**Re: BZA Case No. 20705 / Atlas Doghouse  
1350 E Street, SE (Lot 7006 in Square 1042)  
Applicant's Supplemental Prehearing Submission**

**UPDATED PRELIMINARY FLOOR  
 PLAN OPTION 2.2  
 ADH - CAPITOL HILL  
 APRIL 27, 2022**

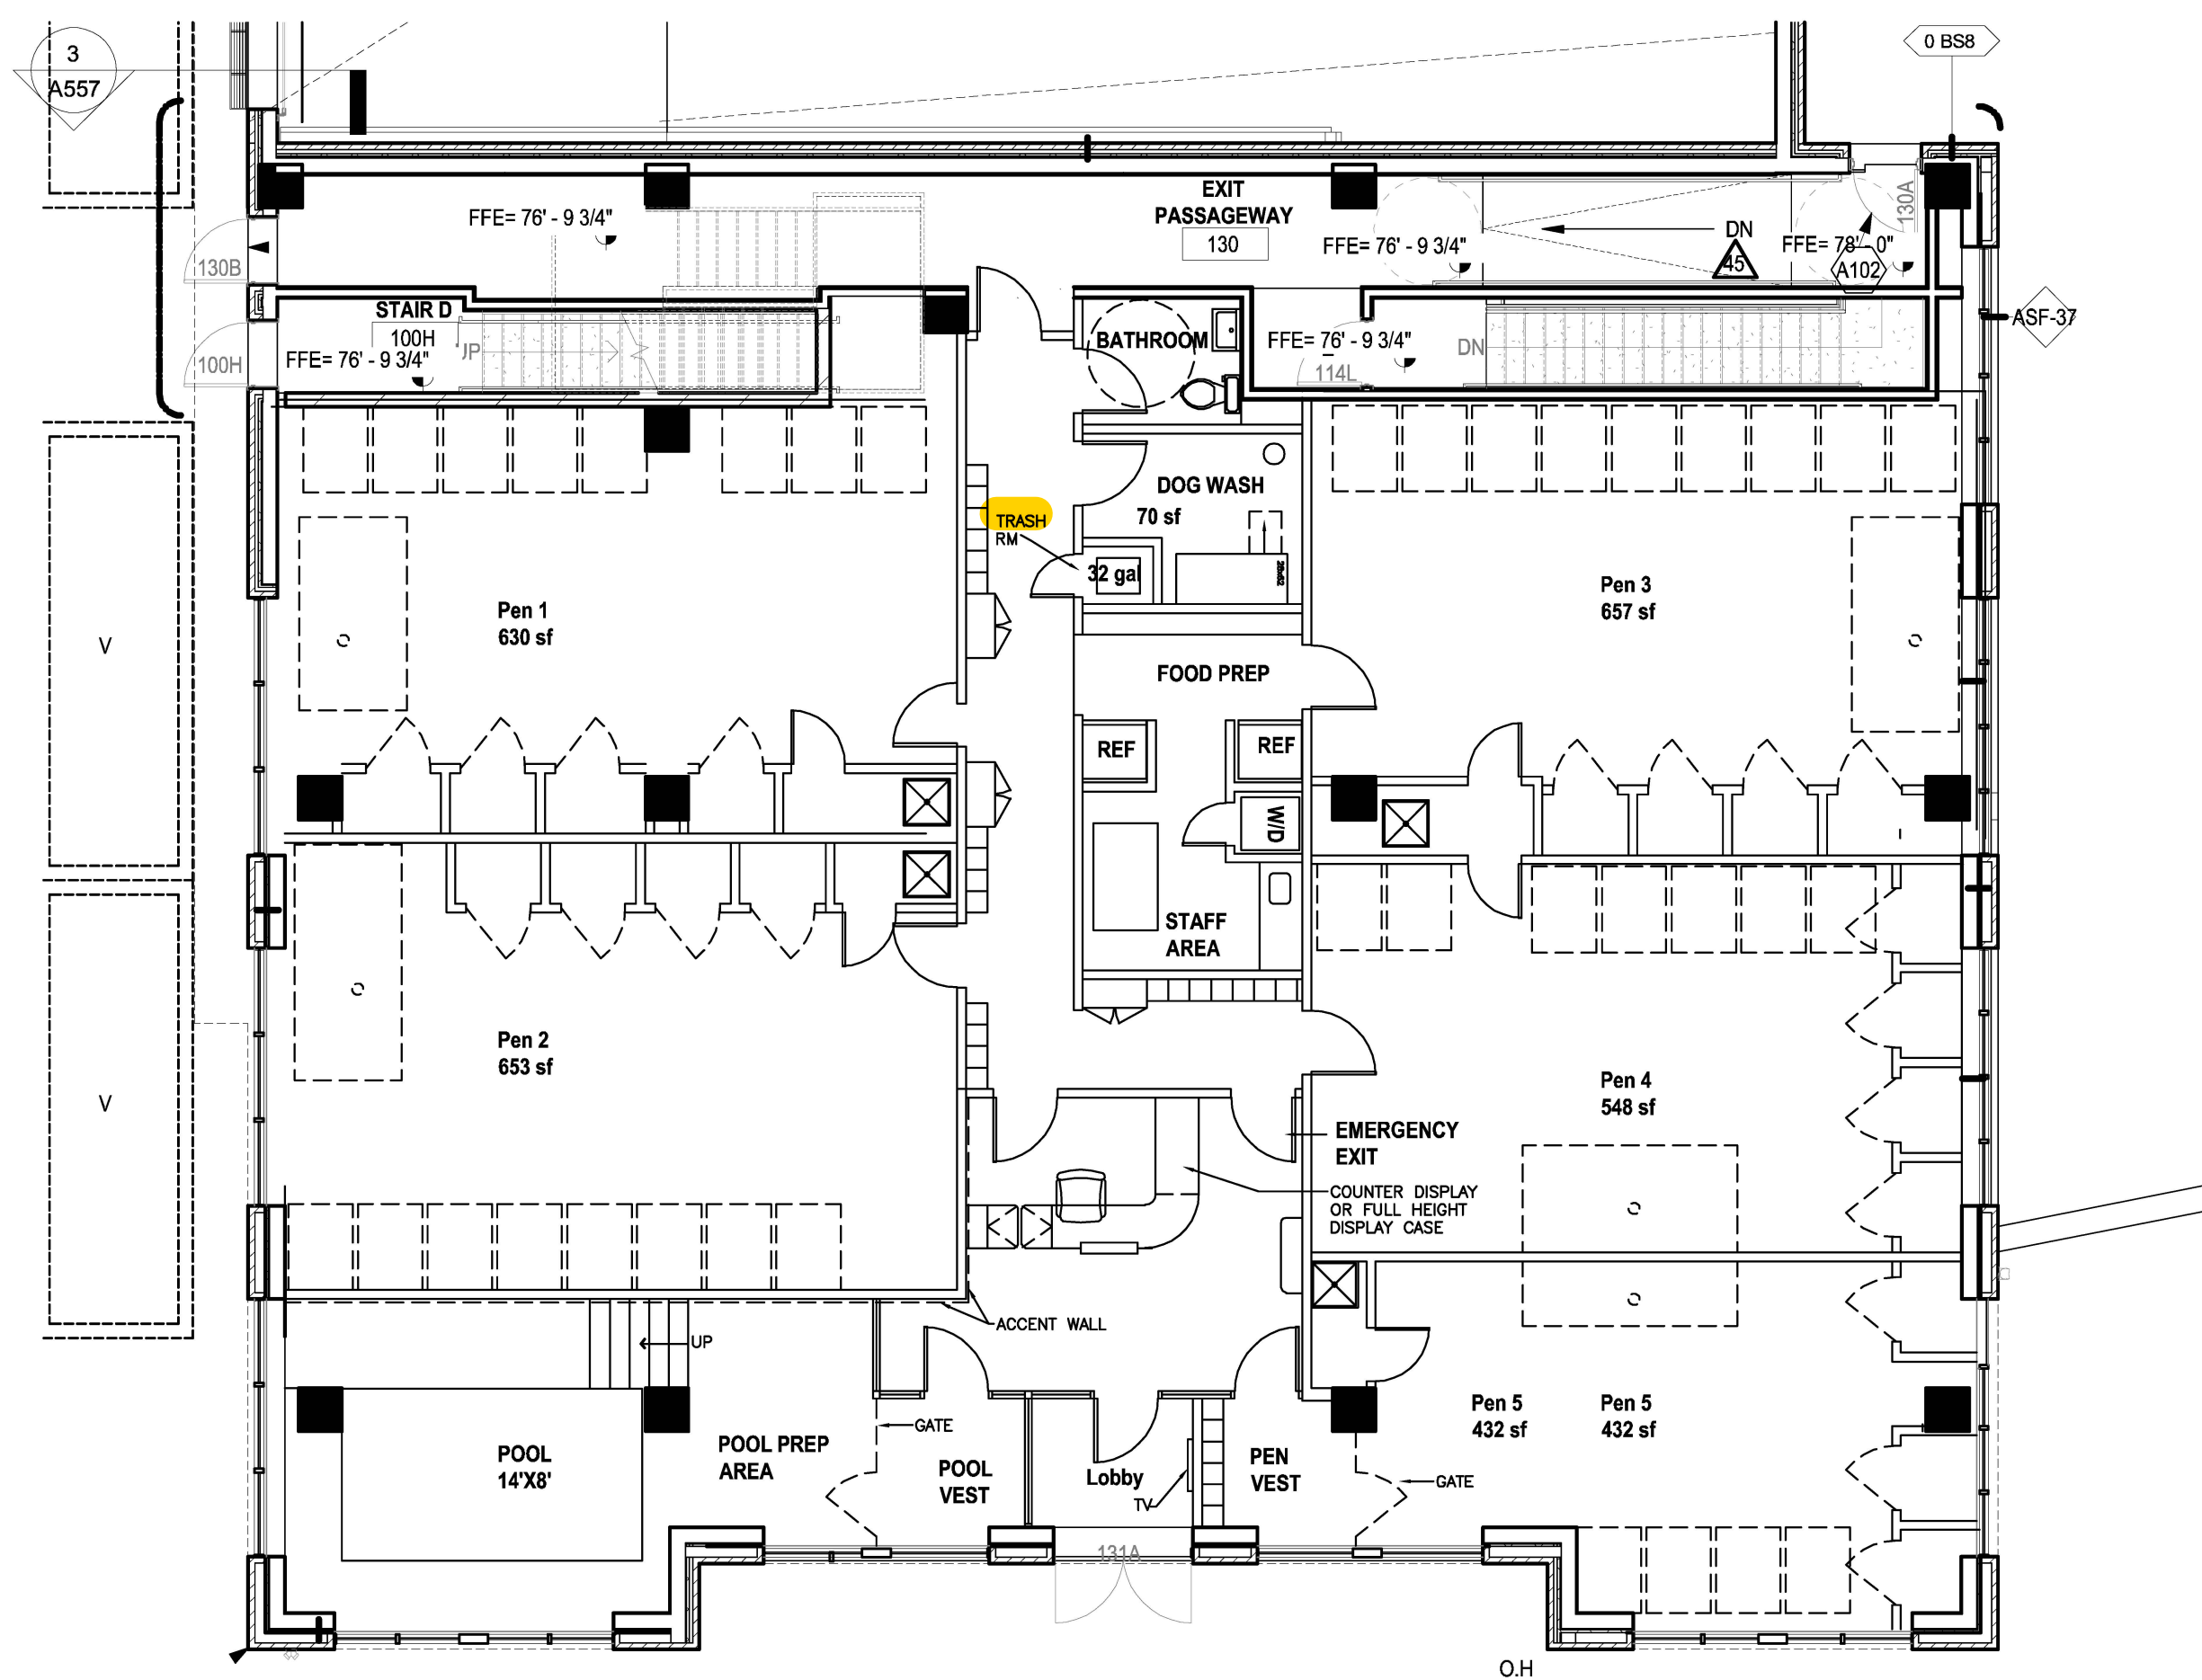
- 1. Identify the storage room on the proposed floor plan for the animal waste disposal containers; and*

The Applicant has identified the designated waste storage room on the updated preliminary floor plan attached hereto under Tab A (the "Updated Floor Plan"). As detailed in the Applicant's Prehearing Statement, the Applicant will implement extensive waste management protocols to counter any potential adverse impacts resulting from unpleasant odors. *See* Ex. 25 at pg. 2. Consistent with the criteria of 11-U DCMR § 513.1(b)(5), animal waste will be placed in closed disposal containers and will be promptly removed from the designated trash area for collection by a privately contracted trash company.
